COMMISSION OF ARCHITECTURAL REVIEW

APPLICATION / CERTIFICATE OF APPROPRIATENESS

Address 2514 East Marshall Street

Scope of Work: Partial Exterior Rehabilitation and Interior Bathroom and Closet Renovation

FIRST FLOOR PLAN

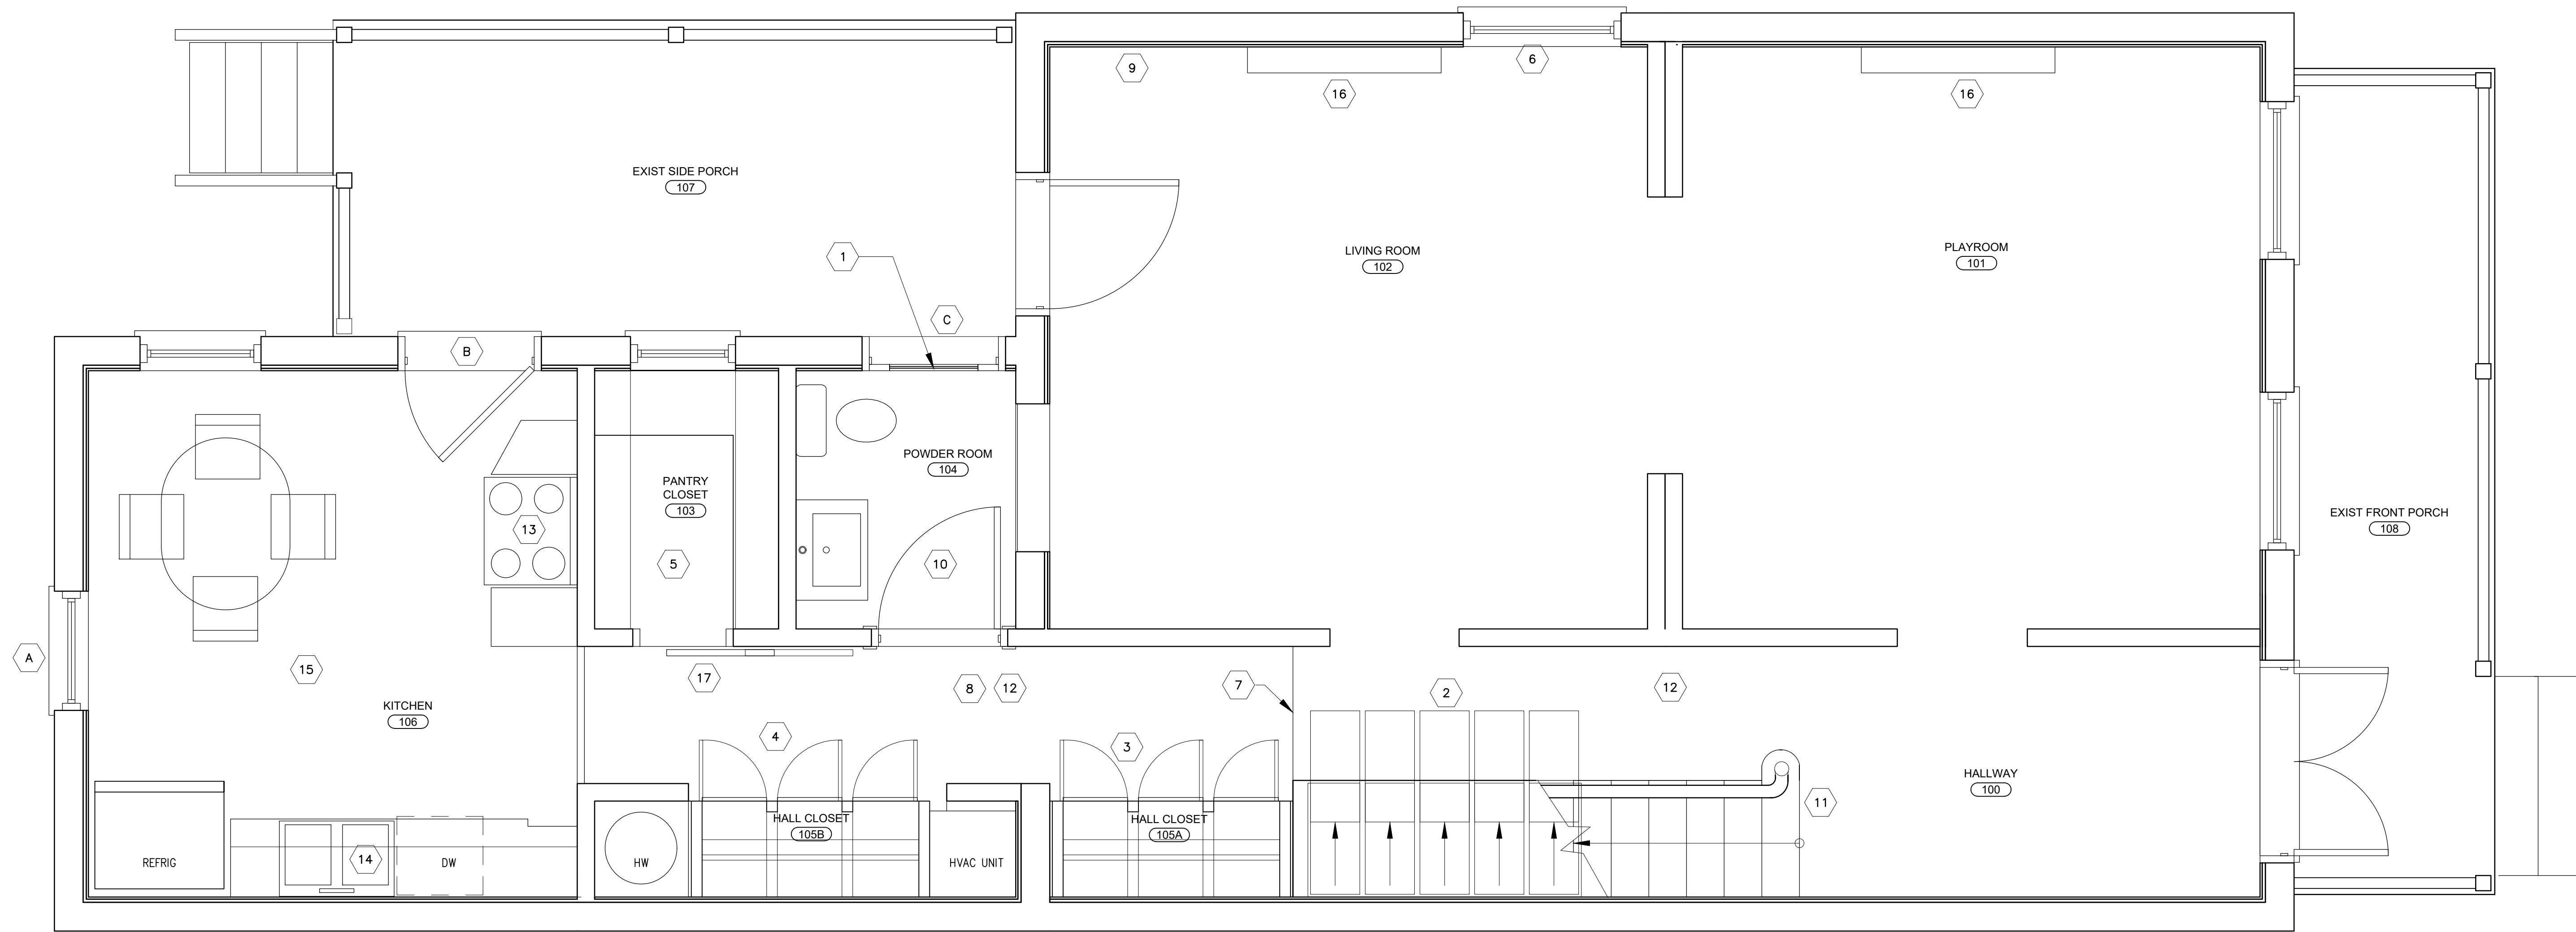
I also wanted to make you aware that an 8ft privacy fence will require zoning approval as I believe the max height allowed is 6.5 feet.

2 EXIST AND PROPOSED WDW AND DOOR REPLACEMENT

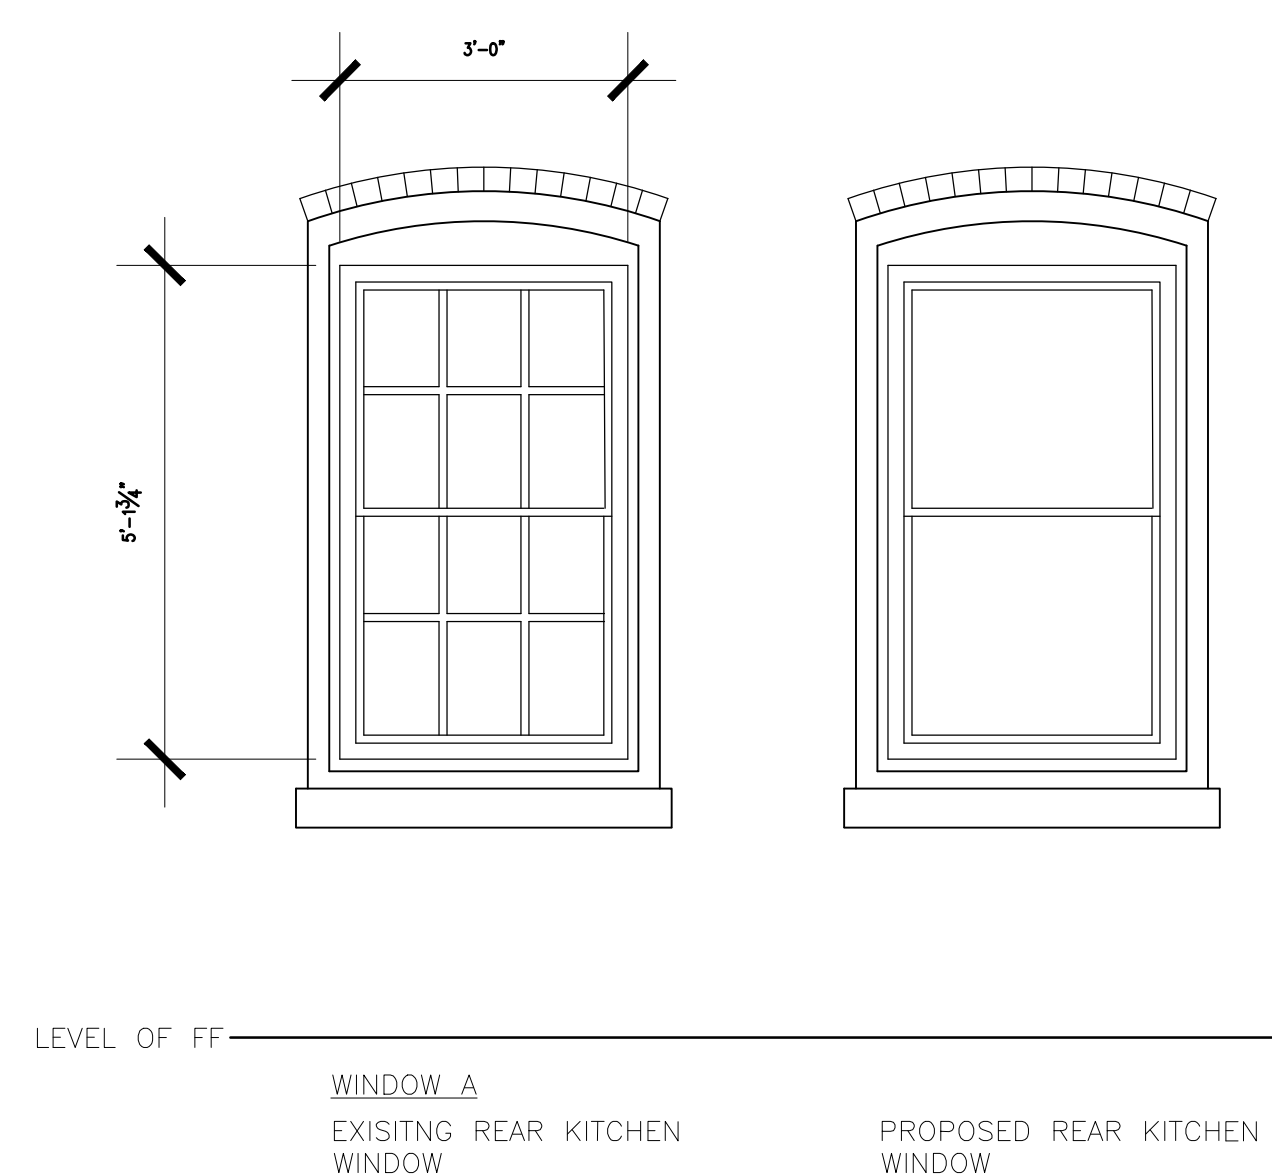
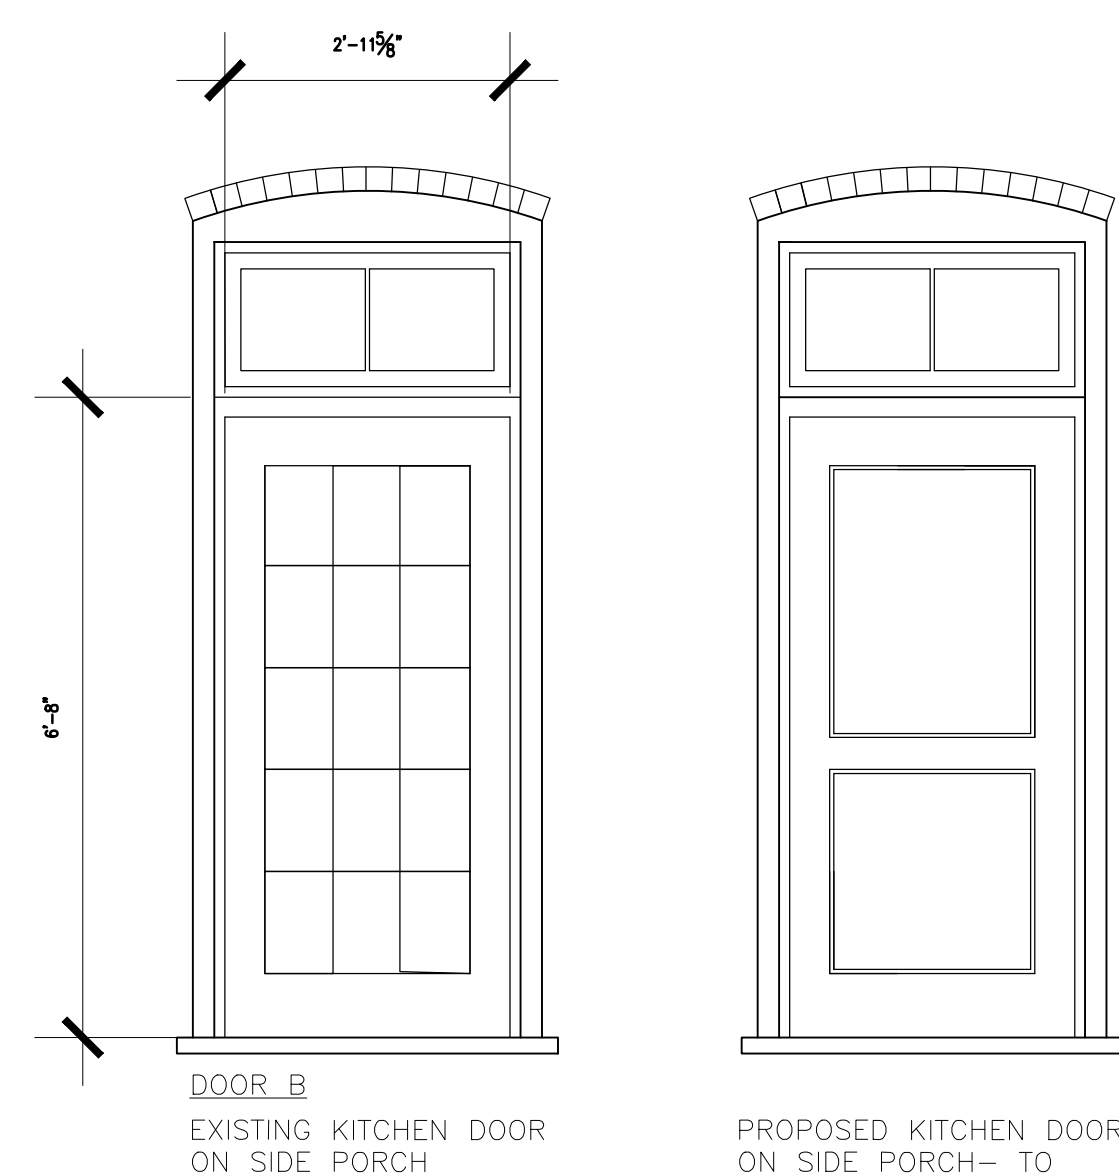
We have attached the photos you requested earlier this week. We tried our best to capture the warped front door. Please note that the side window toward the front has a broken top pane of glass. If that window pane can be repaired without replacing the entire window that is our plan. Please let us know if you require any further detail.

The note I saw was number 15 on A2.1, it looks like it indicates an alternative would be to install six-over-six. So the new window will not have any muntins dividing the sashes? Is the existing window wood?

Oh, yes note 15 needs to be revised to say match the existing. At first, we thought that window was original and the more we looked we think the original is the one over one with no divided lite is original. I would strike Note #15 if you allow matching the existing windows. (I think I incorrectly said two over two in my last email- it has been a long day...)

The window replacements will be wood to match the existing. On Sheet A1.2 Dwg #2 shows the existing window and the proposed window. The proposed window is the two over two panes. I am not sure where you saw the 6 over 6 indicated as proposed (can you give me a sheet and dwg number reference for where you saw this proposed) Does this answer your question?
